TO: Mercedes-Benz Dealer Principals, General Managers, Sales Managers, Service Managers, Parts Managers	FROM: Gregory Gunther, Senior Manager, Vehicle Compliance and Analysis, Engineering Services
RE: <b>Recall Campaign Launch Notification</b> <b>Replace Fuel Pump Delivery Module – Wave 2</b> <b>MY21-24 C-Class, E-Class, S-Class, SL, GT, GLC, GLE, GLS and G-Class (205/206, 213/238, 223, 232, 290, 253/254, 167 and 463 platforms)</b>	DATE: April 5, 2024

Campaign No. 2024010011, April 2024

Revision B 04/05/2024

## **Replace Fuel Pump Delivery Module Wave 2**

Figure 2

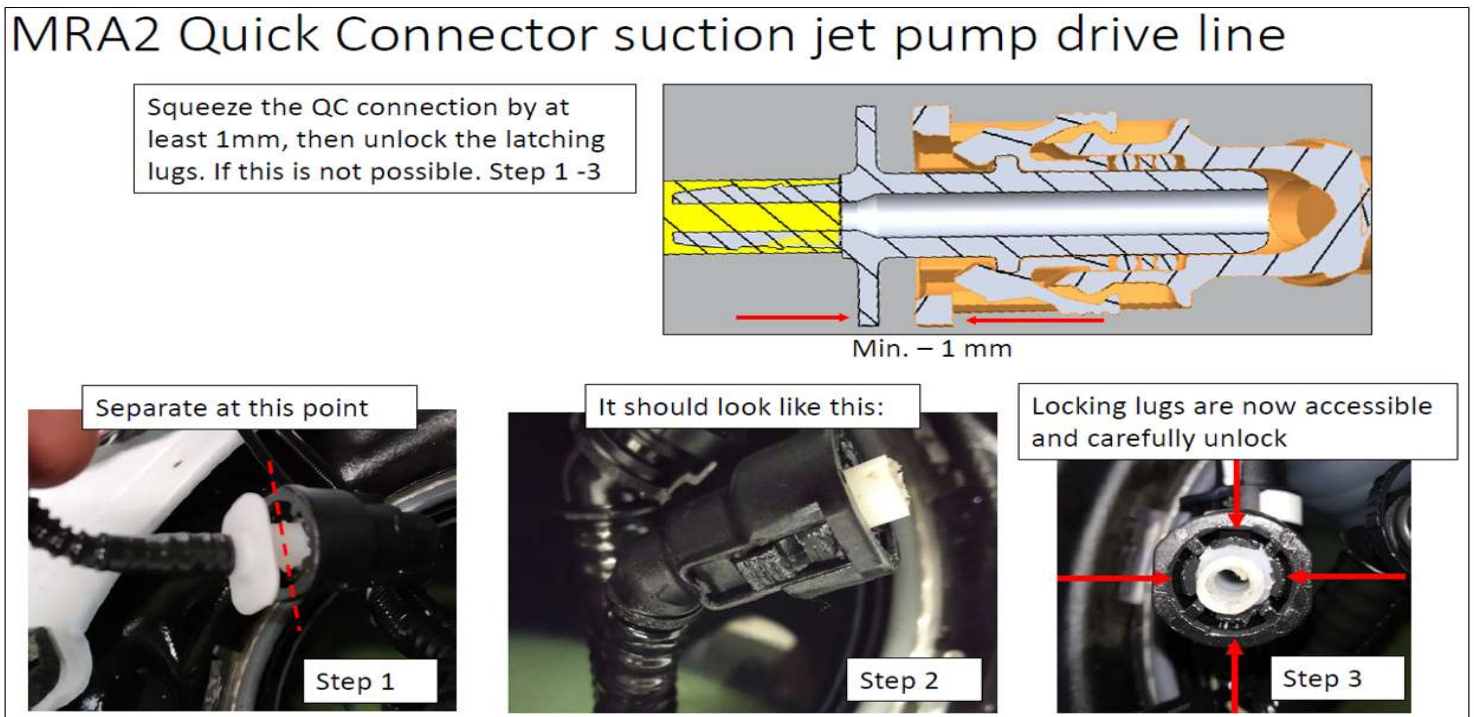
**i** **Only model 206, 232:** Note on disassembly of suction jet pump drive line quick connector.

The procedure steps 1-3 should only be performed when the quick disconnect is not working (**Figure 2**).

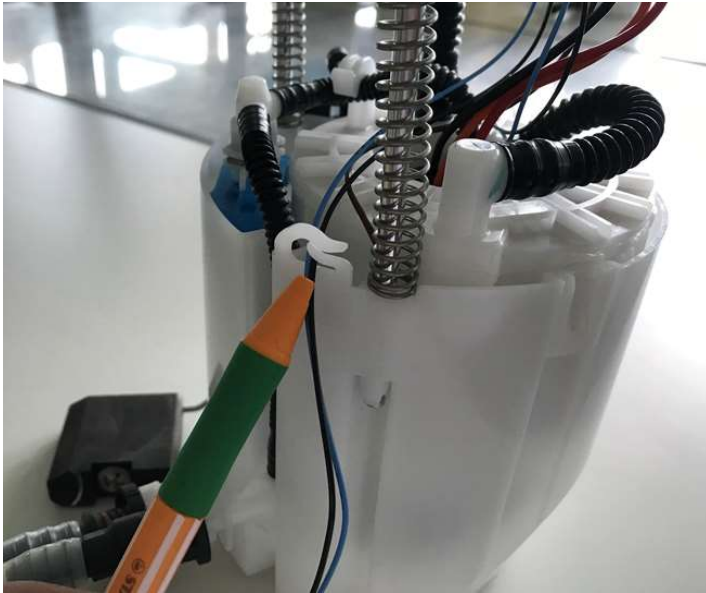
**i** **Only for model 167**

Contrary to the WIS document (**AR88.60-P-2001ME - Remove/install tank filler recess**), the tank filler recess must **not** be removed. Disconnecting the hose lines at the activated charcoal canister and the sealing bellows on the inside at the tank filler recess is sufficient.

**Figure 3**

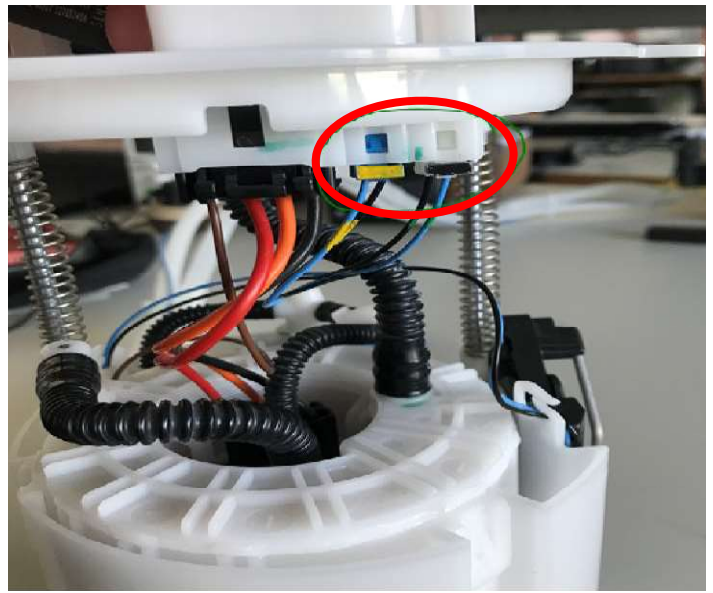
**i** For **all** vehicles with code 228 stationary heater, the connection for the fuel supply system must be cut off before installing the fuel pump (**Figure 3**).

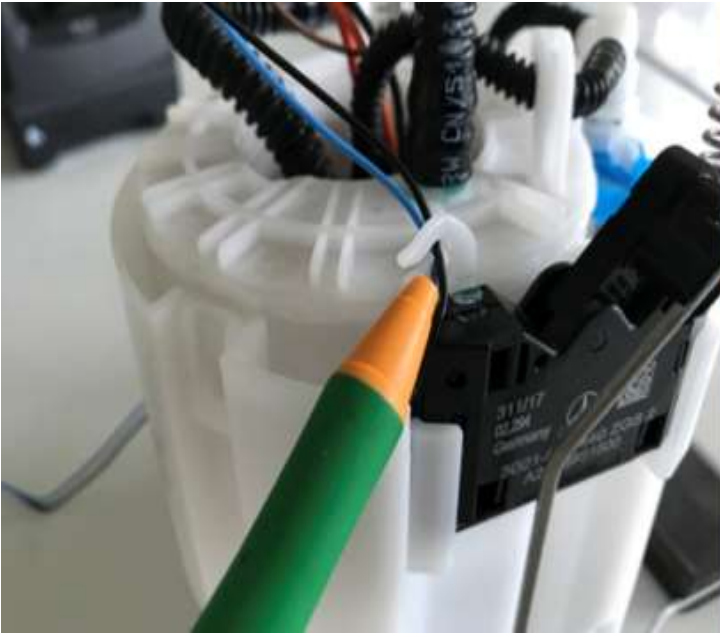
**i** Delivery modules that are delivered **without float-and-lever sensor** must be modified. (**Figure 4-7**)

**Figure 4** (remove electric lines from routing clip)

**Figure 5** (release corresponding connector and disconnect the contacts)

**Figure 6** (remove lines from routing clip)

**Figure 7** (using a screwdriver, carefully push float-and-lever sensor housing away from module housing and at the same time push float-and-lever sensor housing upwards.)
